PARTS LIST FOR MODEL SSV6500

MRP Ver 100612
(based on Penn's Rev. 3 12-01-12)

Penn Reel Parts list for Model: SSV6500 Spinfisher V

DESIGN CHANGES

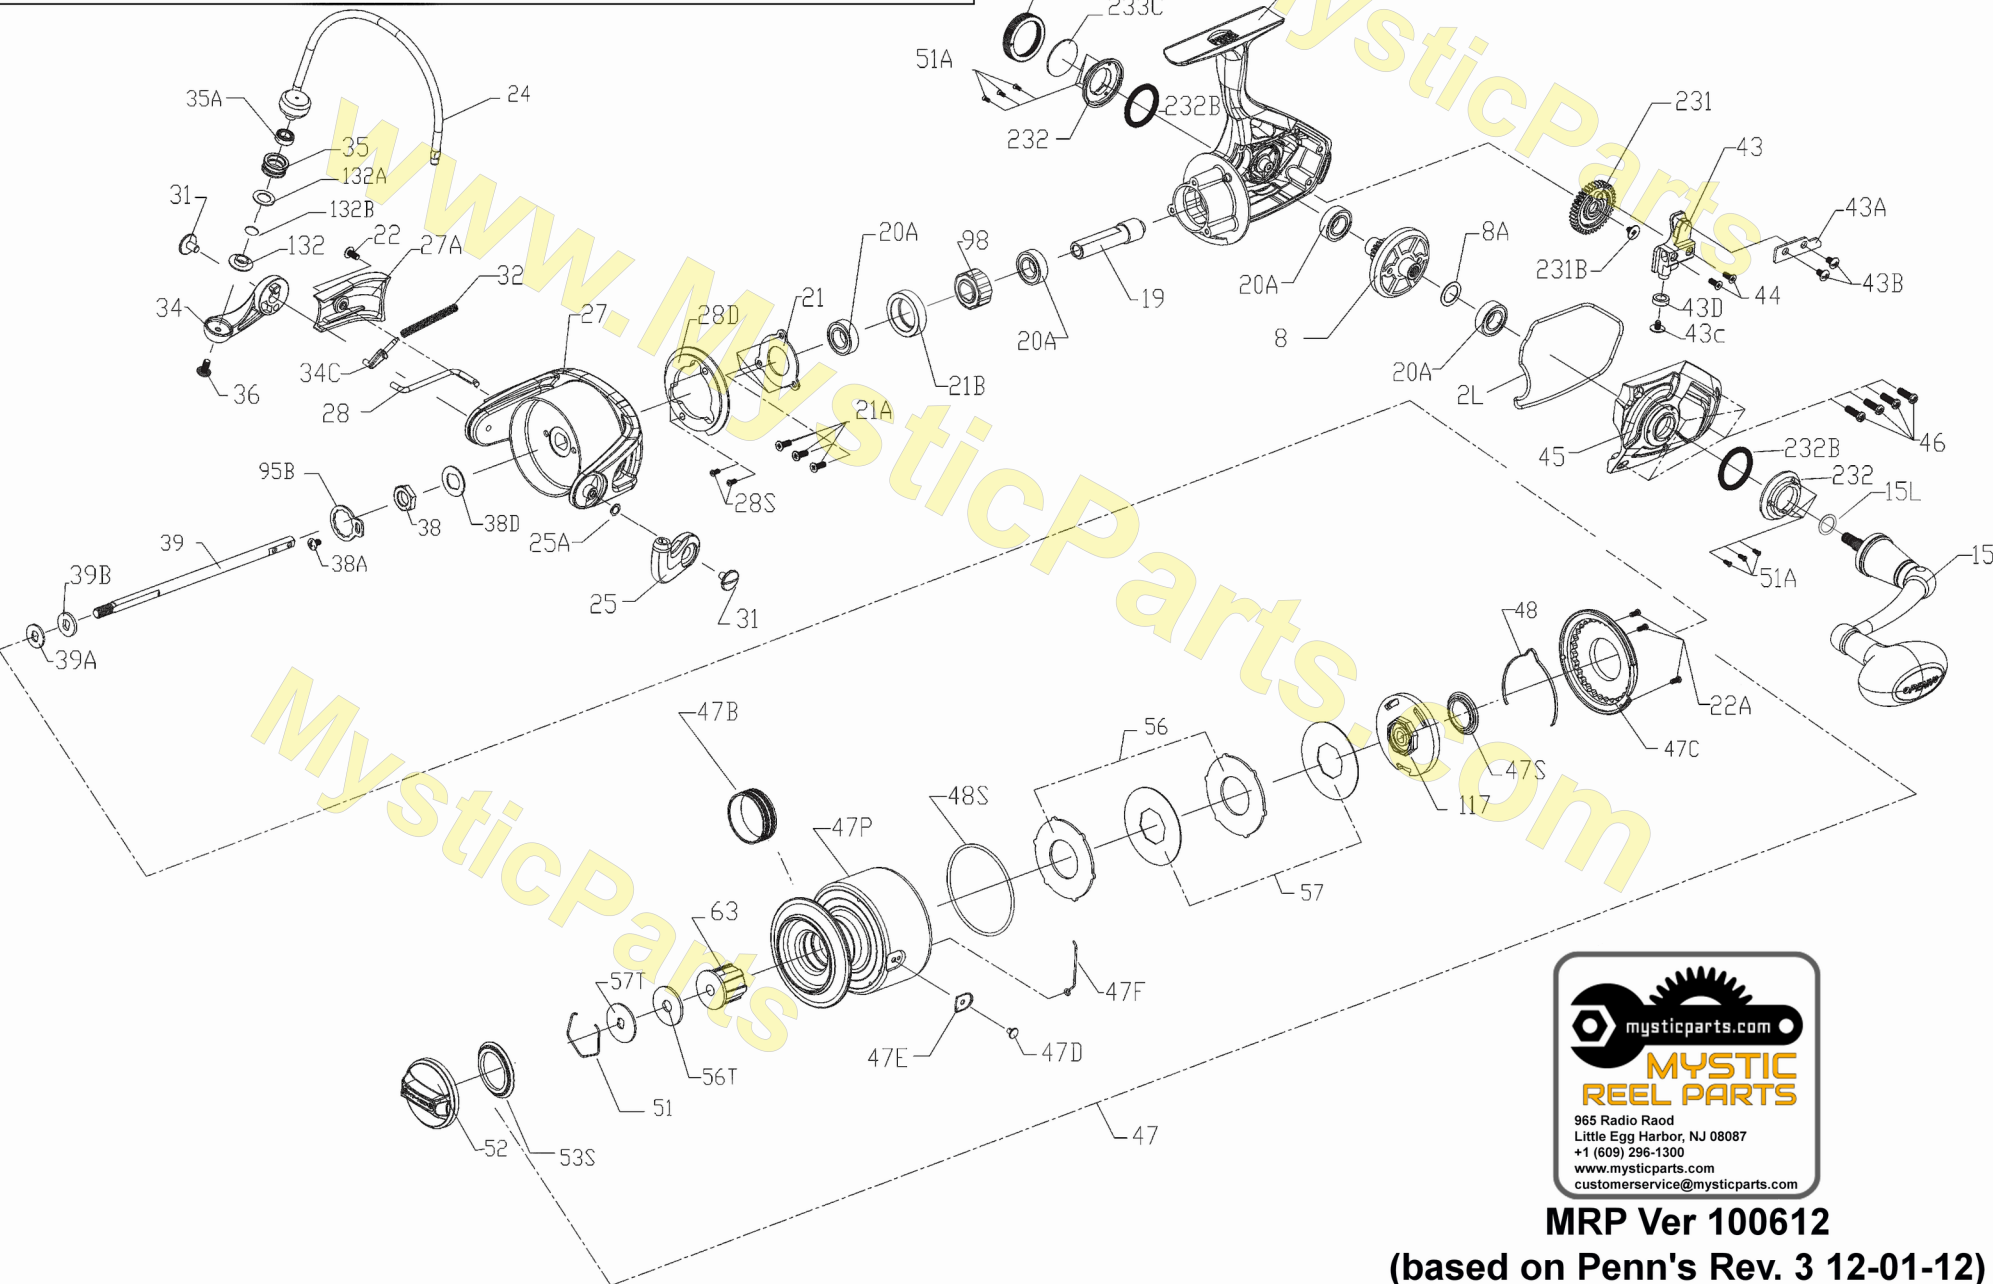
Design Change!
See notes on page 3
about these part numbers

These parts below were removed by Rev 3, we are not yet sure why.

REV 3. Bearing number changes

We are assuming there were errors with the bearing part numbers on the schematic, rather than that they actually changed the bearings.

*****Design change after first run

Early SSV6500 run had a slightly different housing and crosswind gear. The diameter of the hole in the crosswind was almost 3/8". Later runs, the crosswind gear and the pin in the housing that it sits on must have been changed. The current gear I.D. is .23" just under 1/4", current housing matches it.

RECOMMEND TO USE THE REVISION 4 NUMBERS

1	1277105	1-SSV6500	HOUSING, BODY ASSEMBLY with .23 peg
231	1277098	231-SSV5500	CROSSWIND OSCILLATION GEAR 0.23" I.D.
45	1277110	45-SSV6500	HOUSING / BODY COVER
1	n/a	1-SSV6500	HOUSING, BODY ASSEMBLY with .309 peg
231	n/a	231-SSV5500	CROSSWIND OSCILLATION GEAR 1st run 0.309" I.D.
45	n/a	45-SSV6500	HOUSING / BODY COVER
